DVJ-X1 Software Upgrade Ver. 3.00

Applicable Models: DVJ-X1

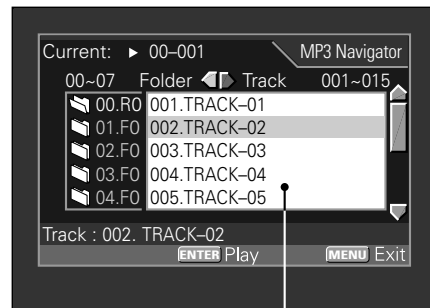
- **The ability to play CD-R/RW discs recorded in MP3 format has been added. Also, MP3 text information can be confirmed via the preview monitor display.**

Total tracks within selected folder
Number of currently playing folder/track

Total number of folders

Displays folder number together with folder name, or “ROOT”.
If folder name is recorded in a code other than English alphanumeric, a numbering series beginning with **“F_001”** will be displayed instead.

Track number and ID3 tag title

If no alphanumeric ID3 tag is recorded, the file name will be displayed. If ID3 tag and file name are not recorded as English alphanumeric, a series number beginning with **“T_001”** will be displayed.

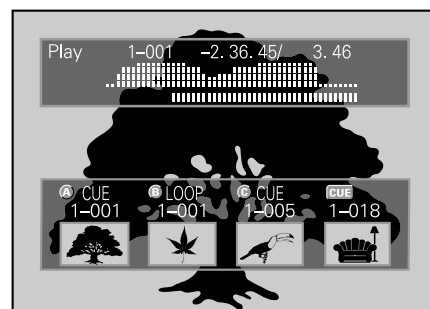
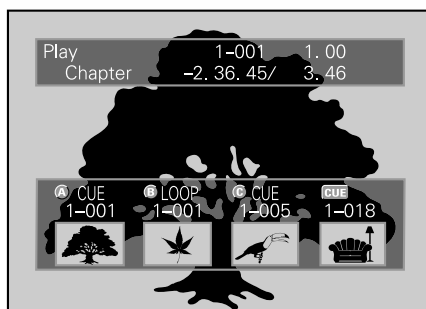
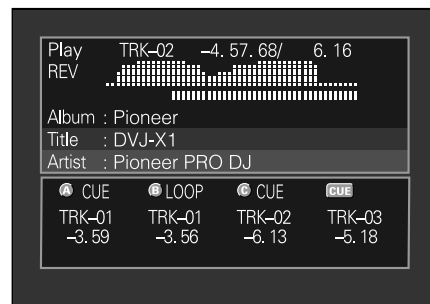
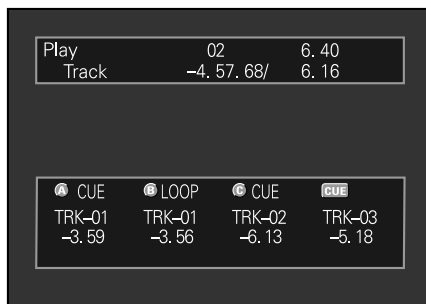
- **One-track loop function has been added.** When the EMERGENCY LOOP button is held depressed for 1 second or more, the current chapter or track is played back as a loop.
- In addition to CDs, **DJ operation with DVDs also now allows digital audio output.**
- **Preview monitor image now adds the playing address and WAVE display.**

With DVDs

With CDs
